**OU1 Design Change and Modification Sheet:
Change/Modification # 33**

OU1-Remedial Action, restoration Seeding Schedule

LIBBY ASBESTOS PROJECT
LIBBY, MONTANA
OU1-REMEDIATION ACTION
PROPOSED OVERALL GRADING
AND RESTORATION PLAN

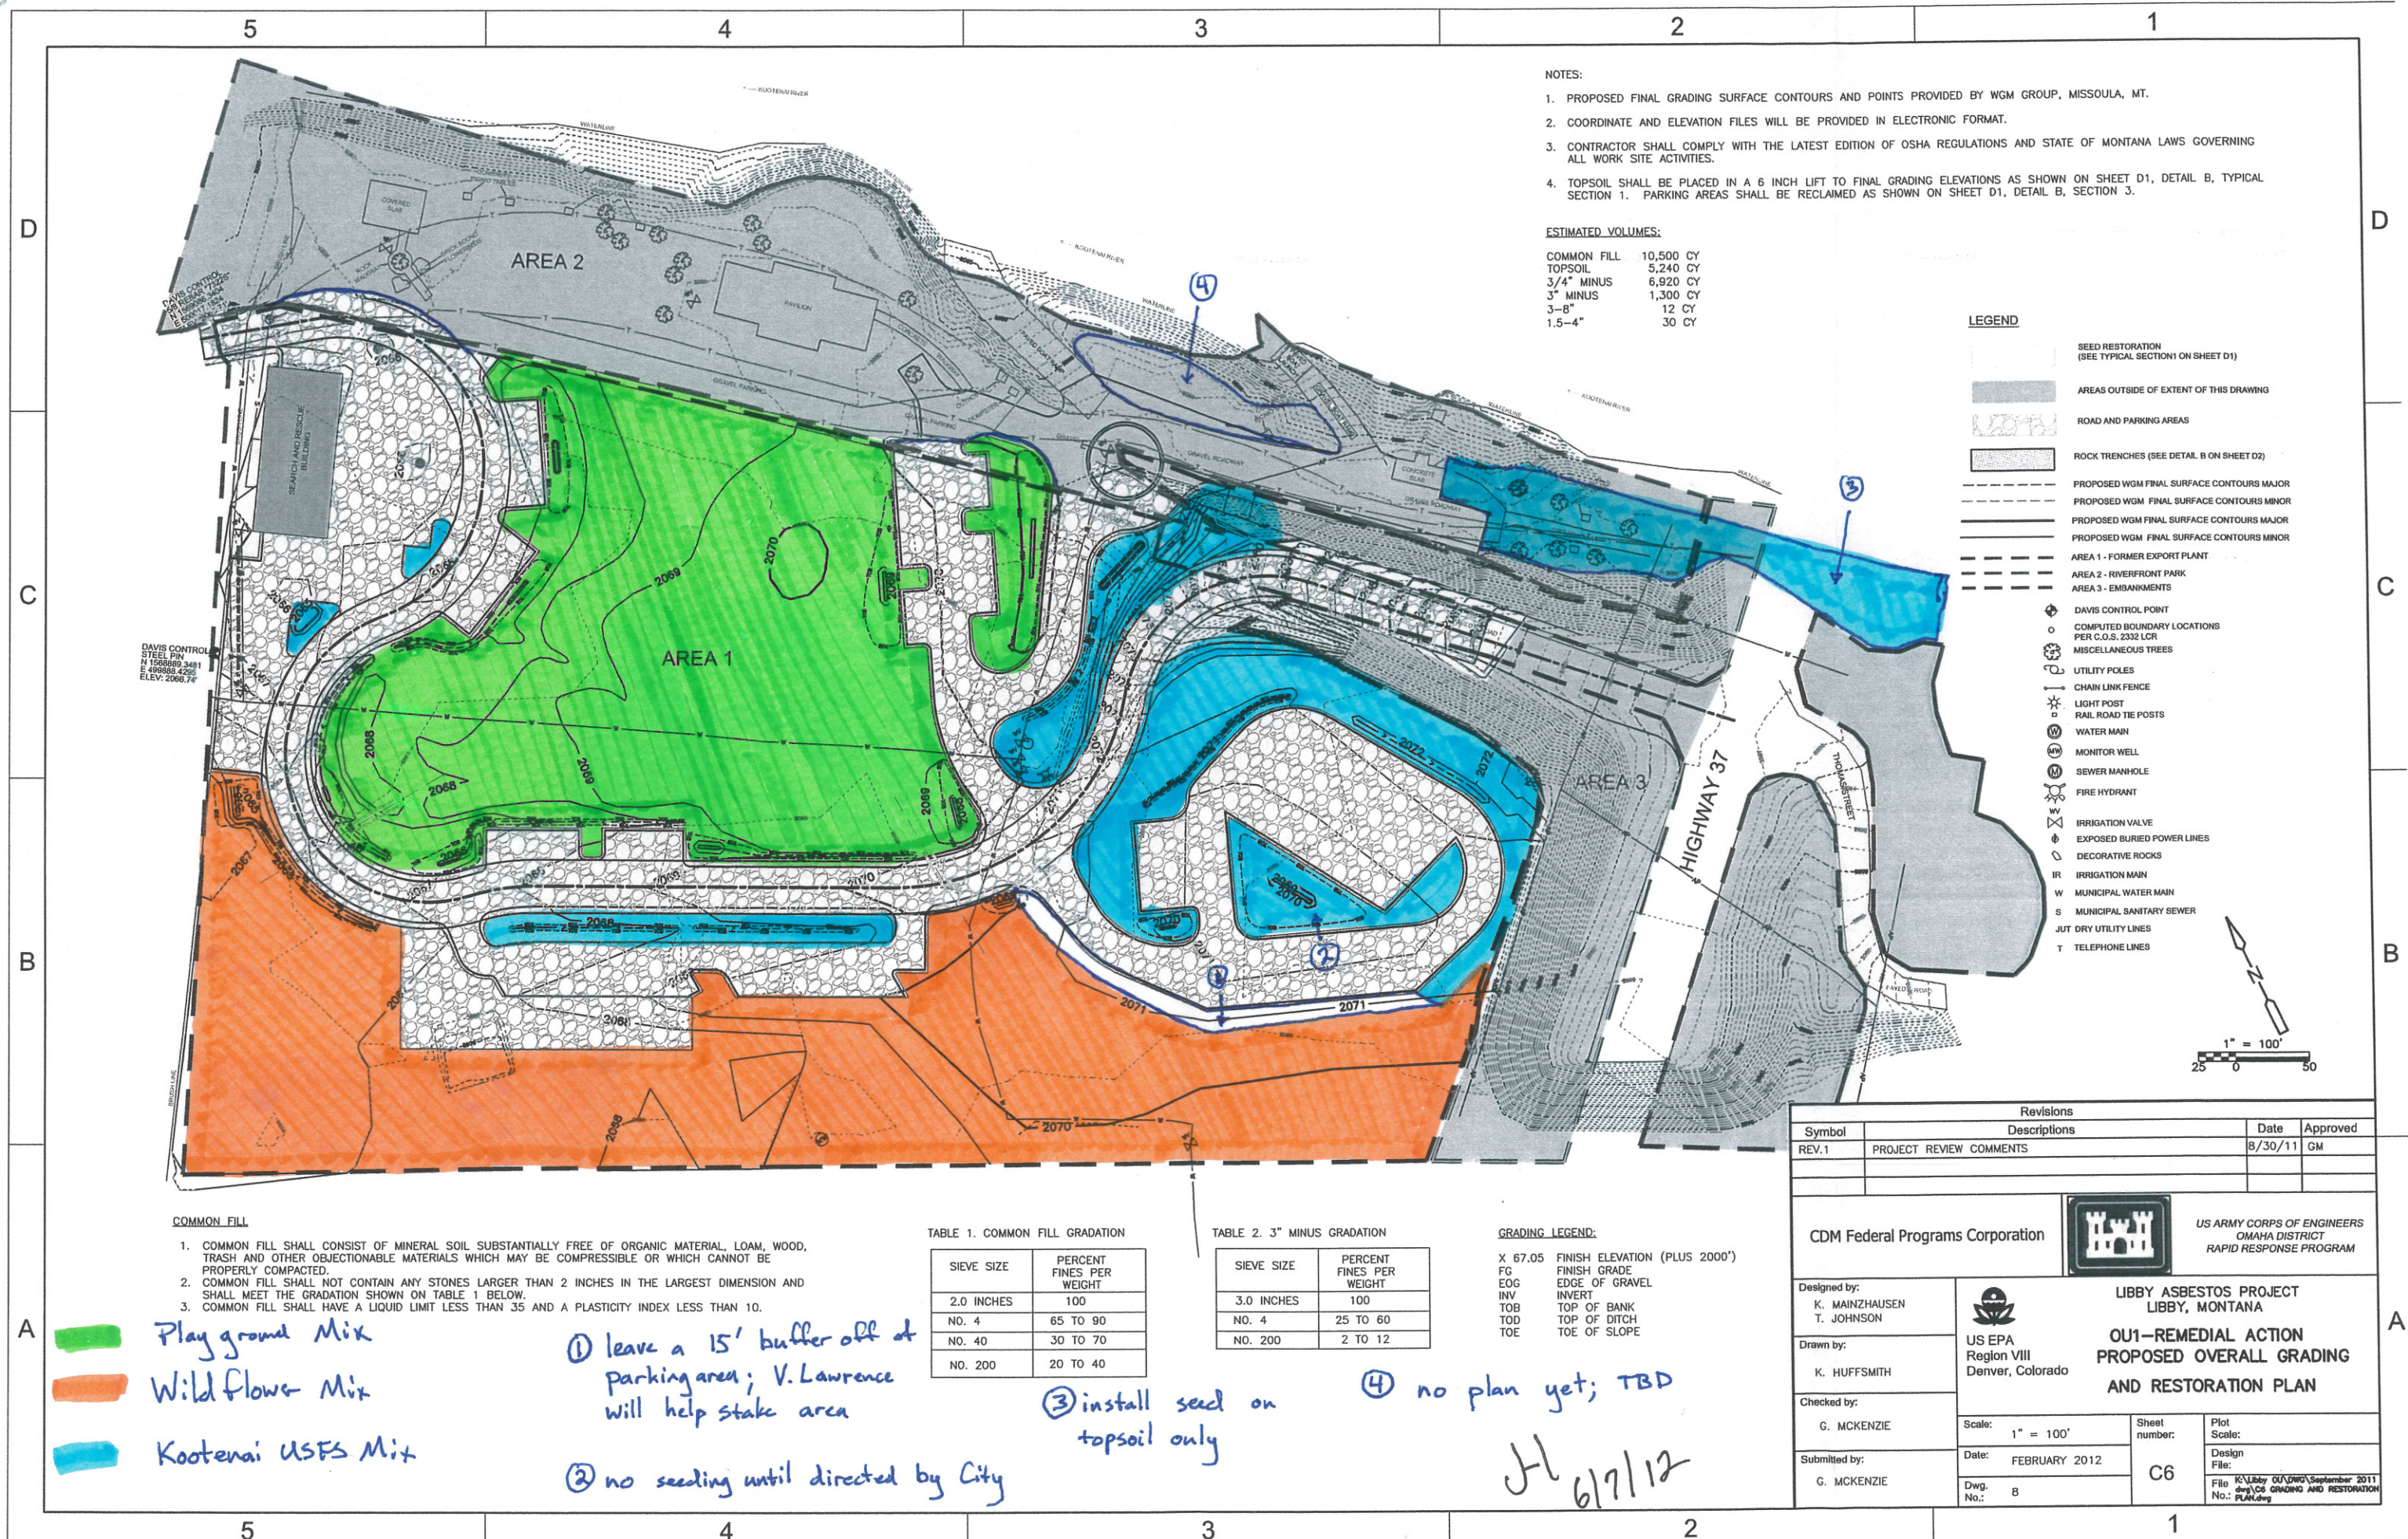
Reference attached drawing for detail.

- Playground Mix
- Wildflower Mix
- Kootenai USFS Mix

- ① leave a 15' buffer off of parking area; V. Lawrence will help stake area
- ② no seeding until directed by City
- ③ install seed on topsoil only
- ④ no plan yet; TBD
